Re: Assessment of Mine Water Treatment Options
1A Mine Pool, Town of Dominion, Cape Breton County, Nova Scotia

Managing Mine Water Quality and Flow in the 1A Mine Pool – Phase 1

TASK 1 – INITIAL OPTIONS REVIEW REPORT

Figure 4

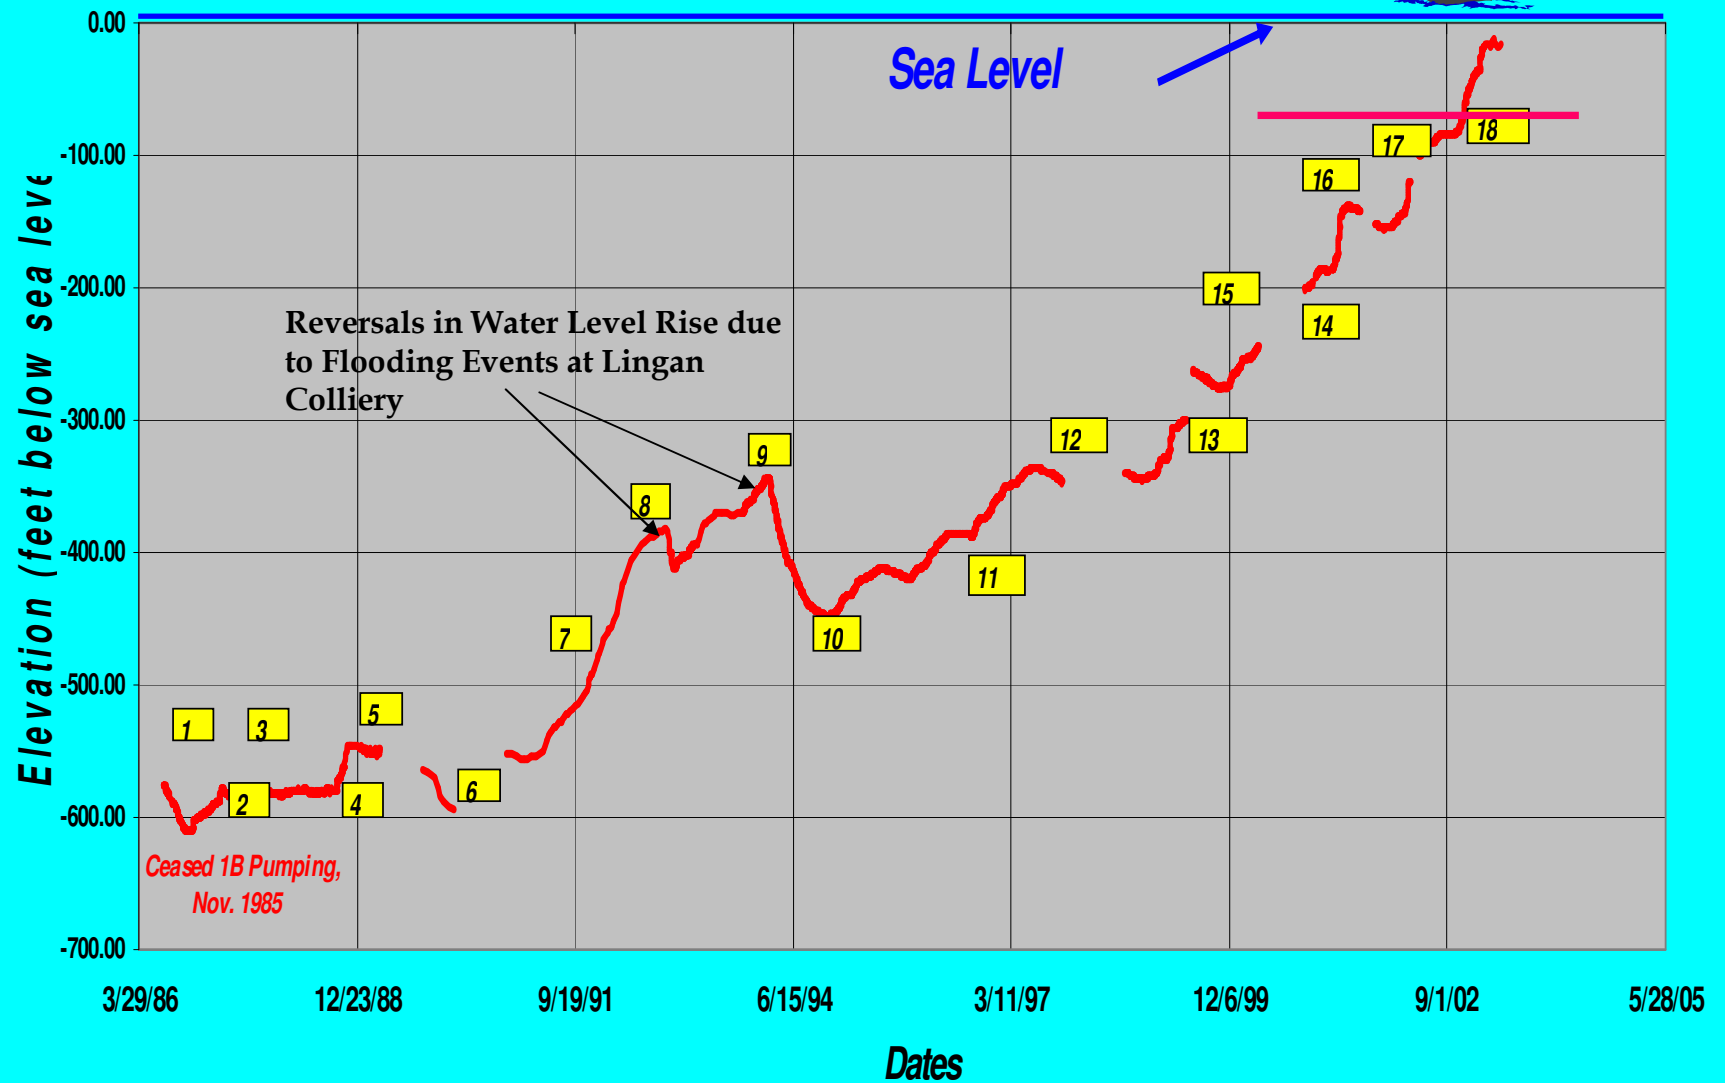
1. Figure 3 –
 - a. In 1A mine, it has “Nov. 1996”, but at the bottom of this figure, it says “from CBDC -----, Sept. 1993.”
 - b. There are no Mines 14 and 17 in Figure 1 showing where those two mines were located
2. Figure 4 – what do the numbers in yellow squares mean?
3. **Flooding of the 1B Hydraulic System – 3rd paragraph, 2nd from the last sentence “ additional inflow were experience at Phalen Colliery as its production longwall units extracted coal under flooded Harbor Seam workings.”**

Figure 5

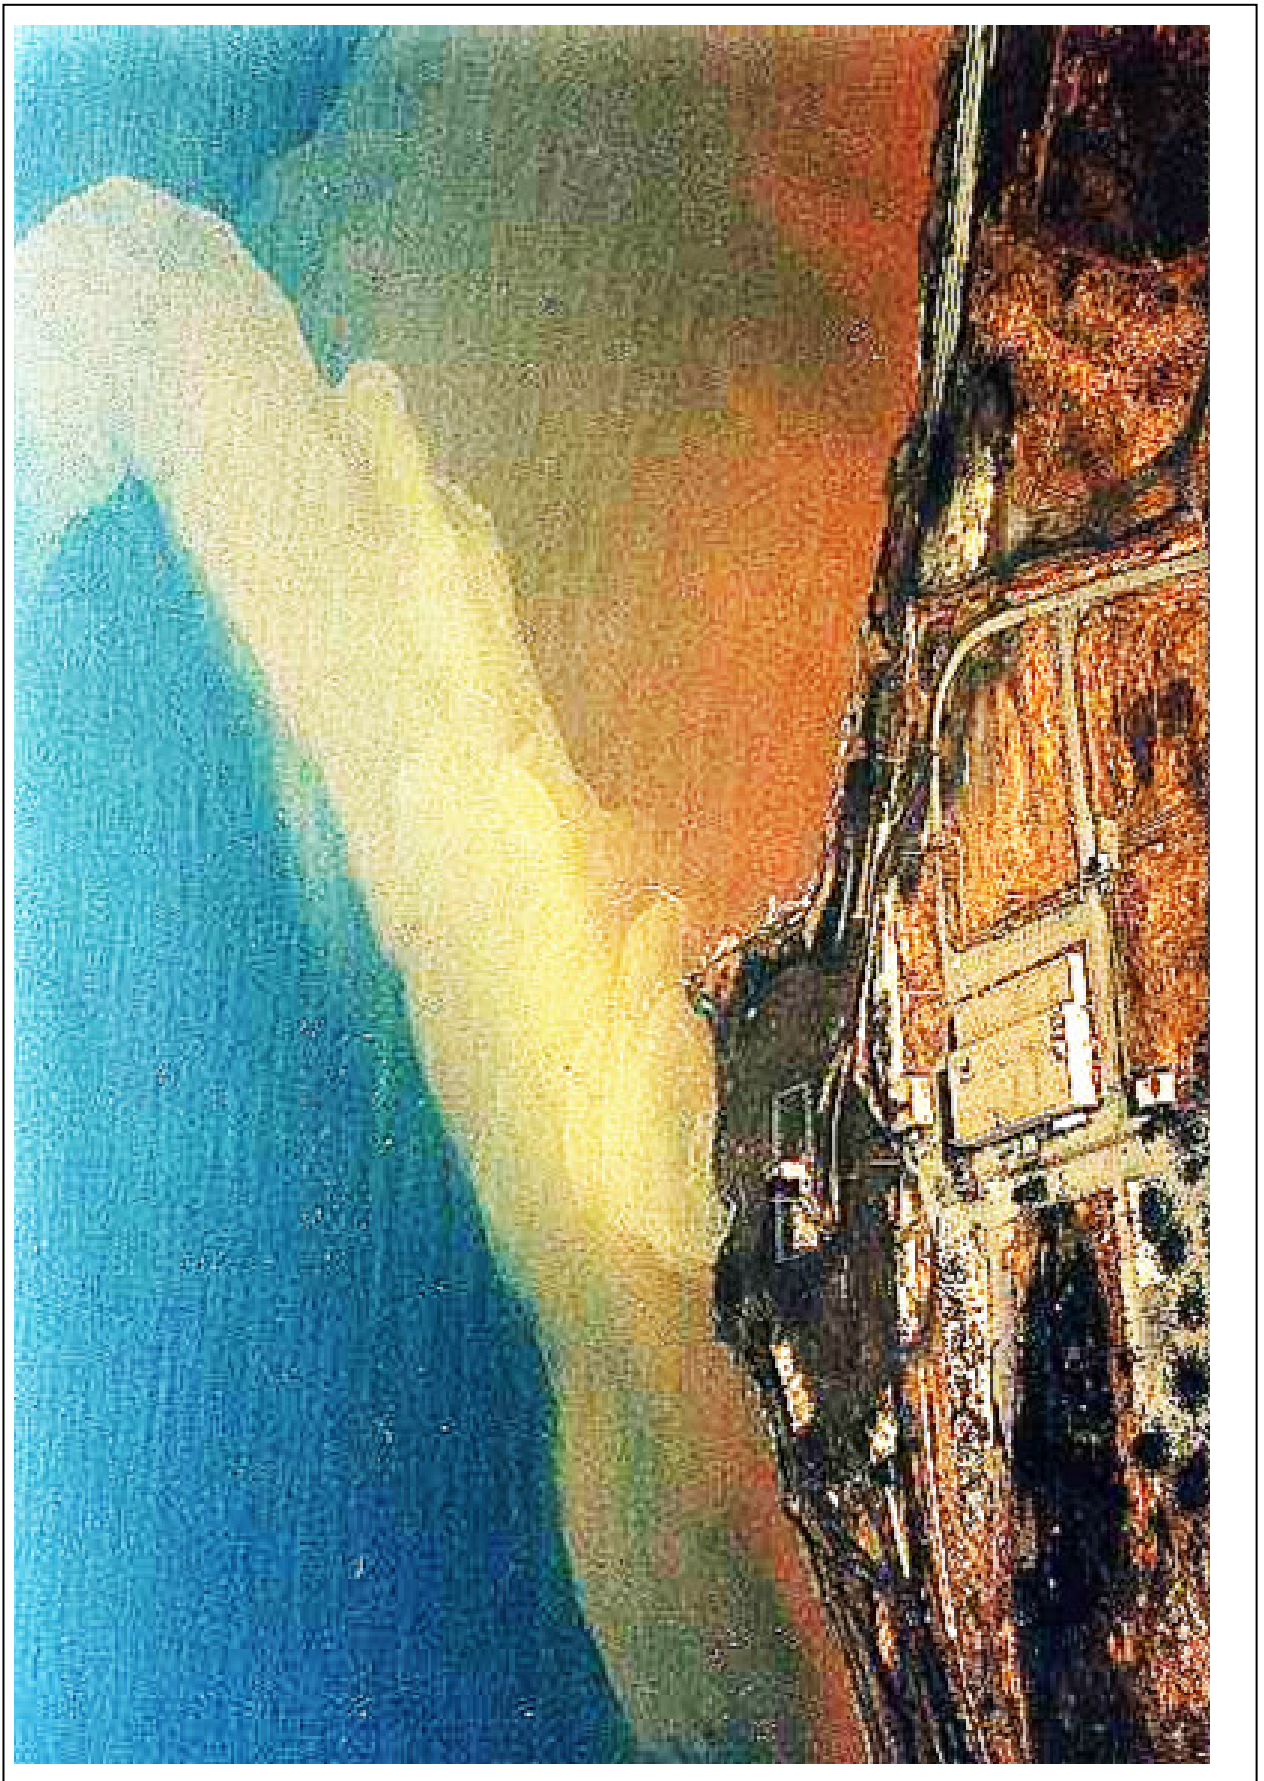
Wasn't it true that water in Phalen was mainly from the sandstone between Phalen and Harbor seam, it was not sea water ?
4. Figure 5 – no legend to indicate what the readers are looking at..
5. **Volume of Water in the 1B mine Pool –**
 - a. **2nd paragraph** -How did you estimate the residual void space?
 - b. **4th and 5th paragraphs** – In the 4th paragraph, I understood how did you get the 20 billion gallons, but in the 5th paragraph, I did not get where the 80 billion gallon came from?
6. **Mine Pool Quality – 2002 to present**
